**RE: Application for Permit Approval Amendment Modification
SEP-2016-12 (File #1582A)
164 Enterprise Drive, Monroe, CT
Project Number: 1604501**

PERMIT APPROVAL AMENDMENT MODIFICATION

Subject: Permit Approval Amendment Modification for
P&Z: SEP-2016-12-A1 (File #1582A)
164 Enterprise Drive

Sheet Title:	Sheet #:
LANDSCAPE PLAN	2.61

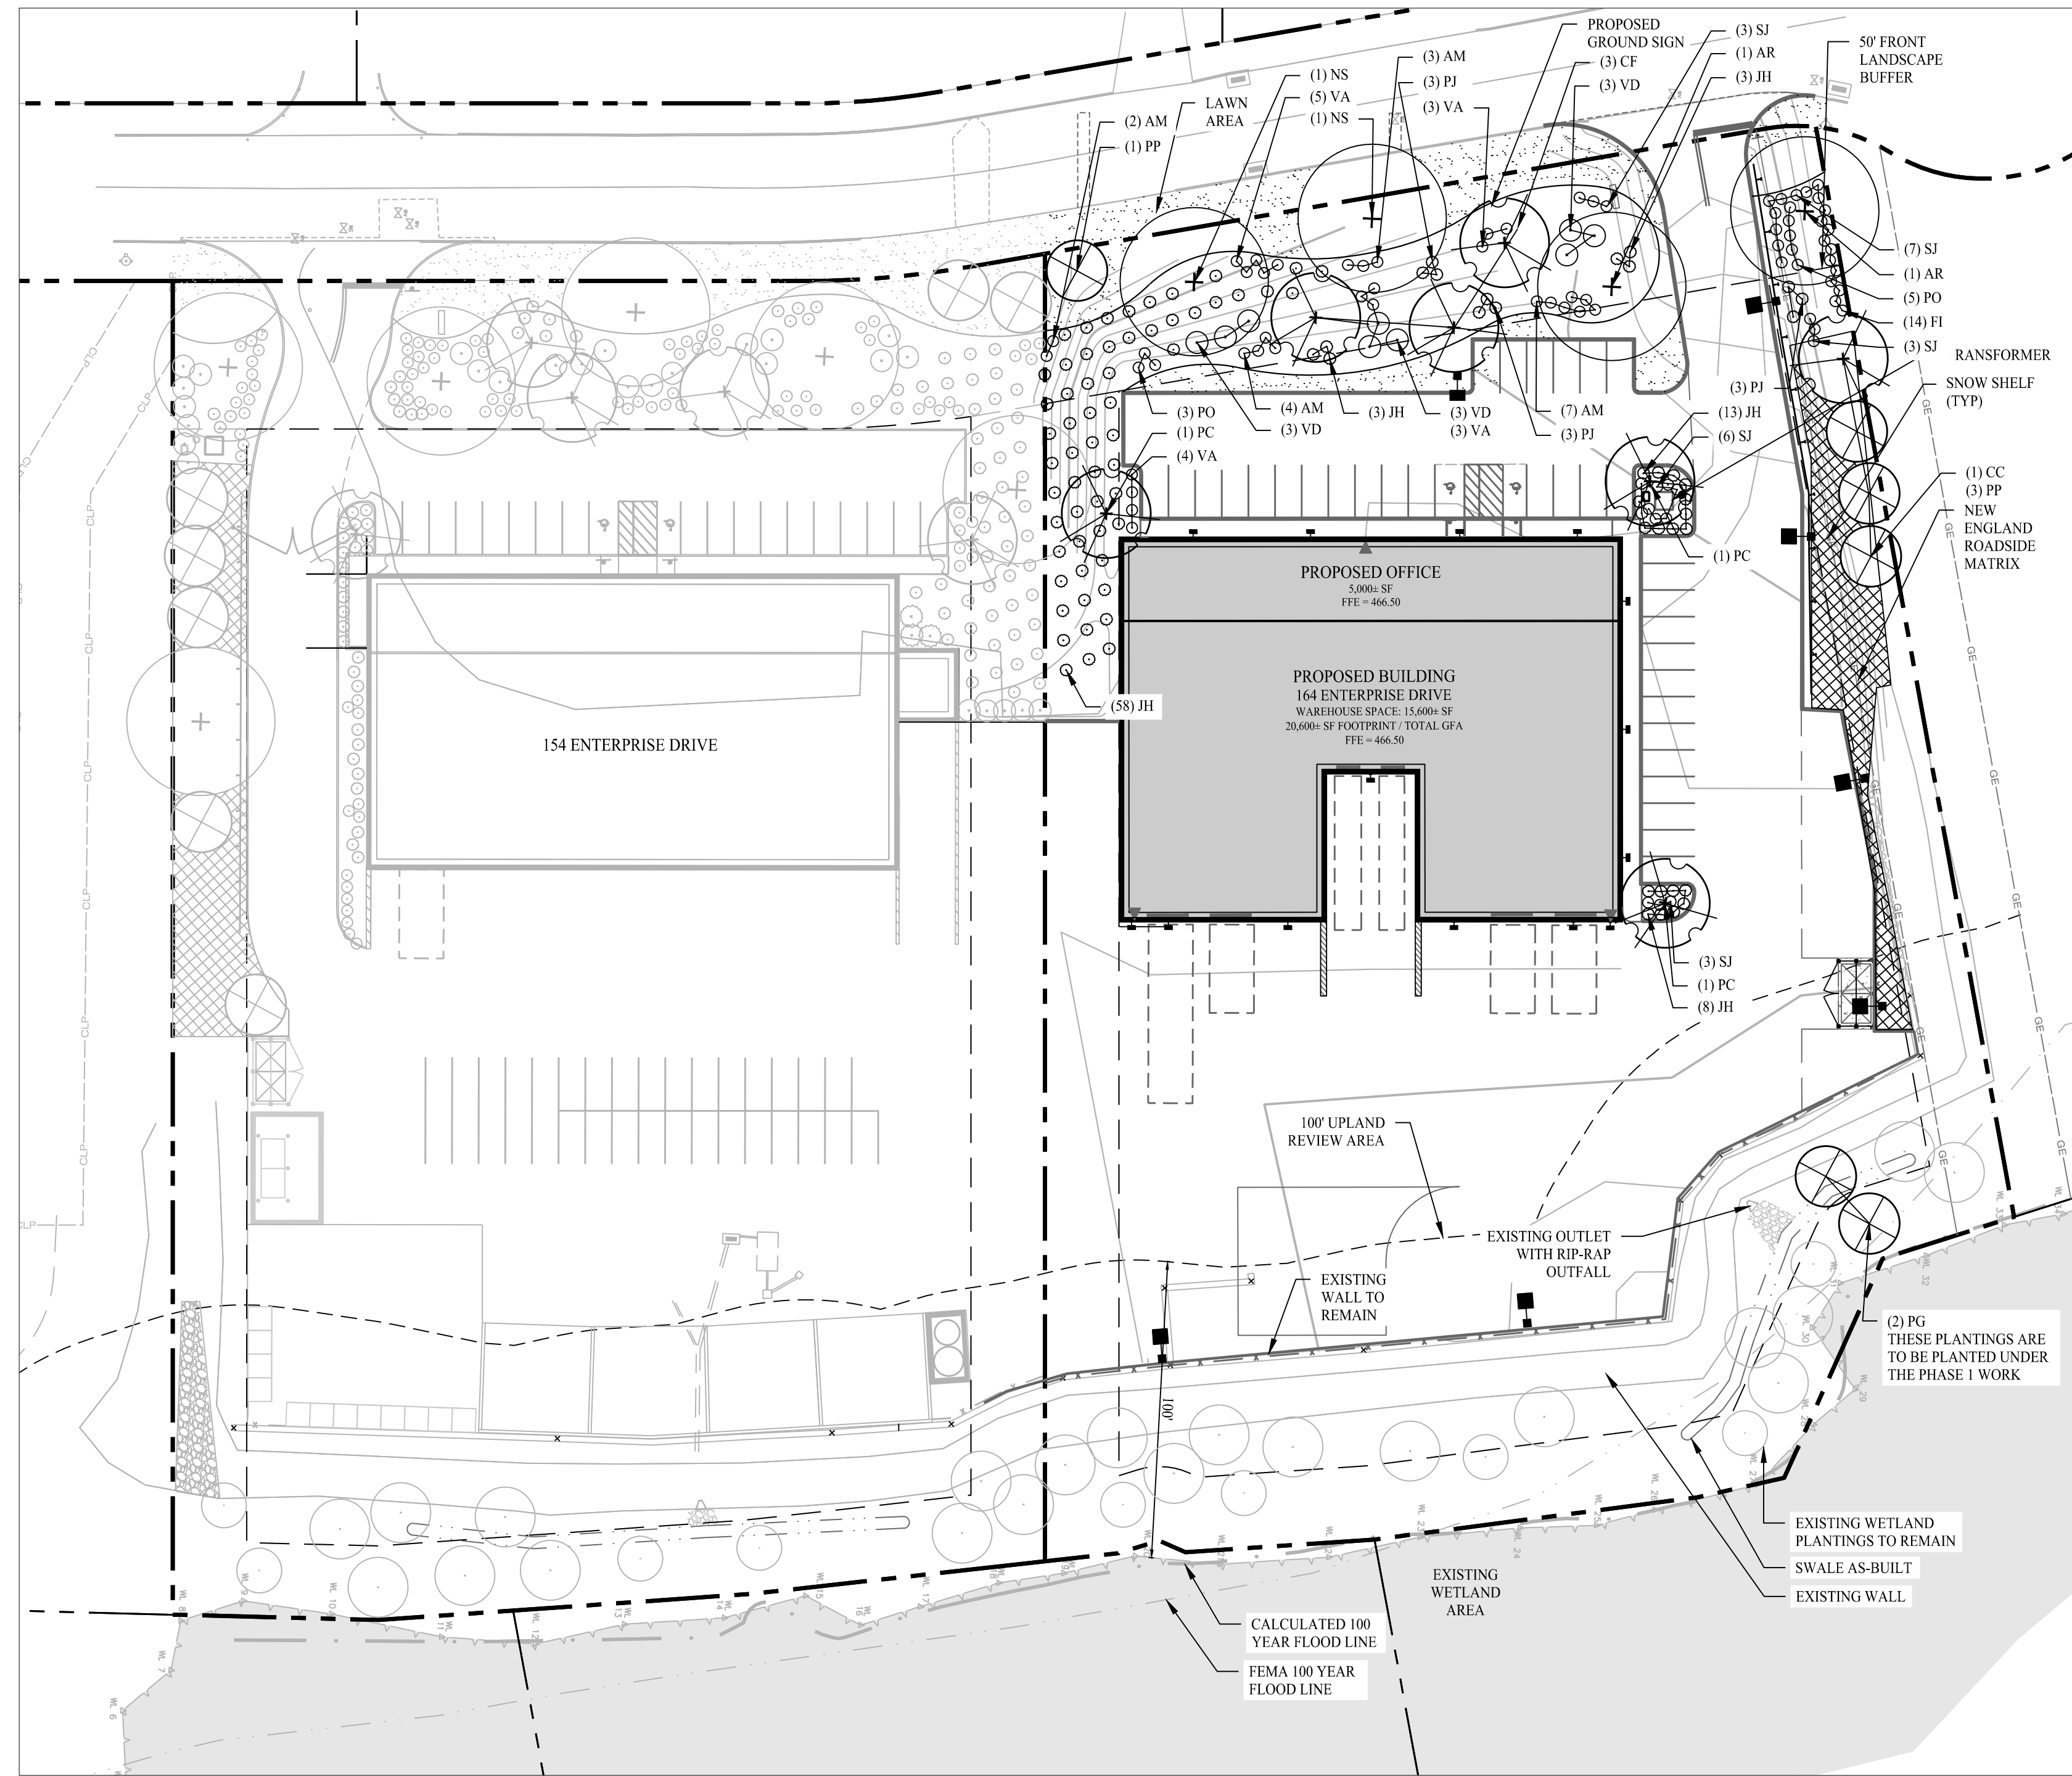
The Permit Approval Amendment Modification application includes The Landscape Plan, Sheet 2.61. Below is a list of modifications to the previously approved Plan:

- Plants in the landscape island at the north east corner of the building have been shifted to reflect the revised location of the island with the exception of three (3) Spirea shrubs and three (3) Juniper groundcovers that were moved from this island to the front landscape bed.

Sheet Title:	Sheet #:
LIGHTING PLAN	2.71

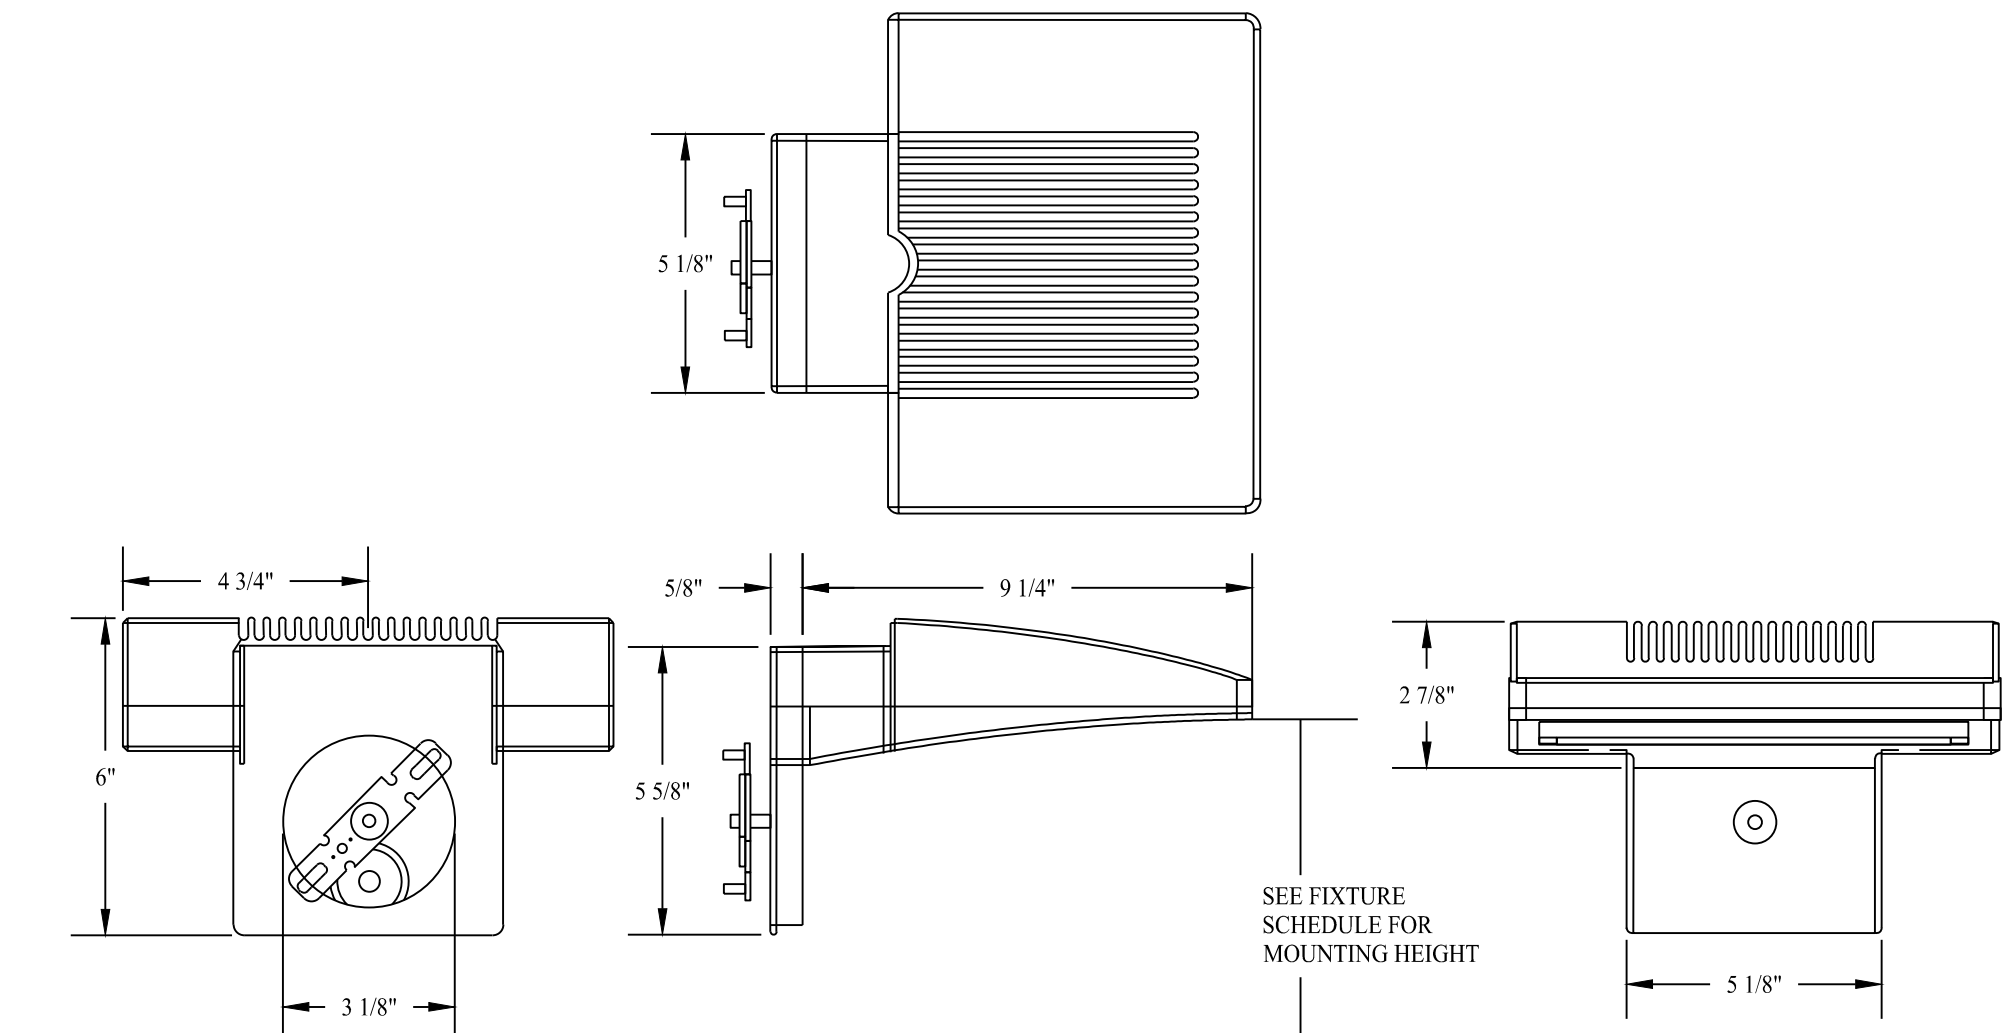
The Permit Approval Amendment Modification application includes The Lighting Plan, Sheet 2.71. Below is a list of modifications to the previously approved Plan:

- The four wall mounted lights along the front (west) façade of the building have been changed from a 15' mounting height to a mounting height of 16'-6"
- The three wall mounted fixtures along the side (north) façade of the building have been changed from a 15' mounting height to a mounting height of 15'-6"
- The location and mounting heights of the seven (7) wall mounted fixtures along the back (east) façade of the building have been revised to reflect the changes to the building footprint. All fixtures were previously approved with a 15' mounting height. Four (4) of the fixtures are proposed for a mounting height of 15'-6" and two (2) are proposed for a mounting height of 8'9".
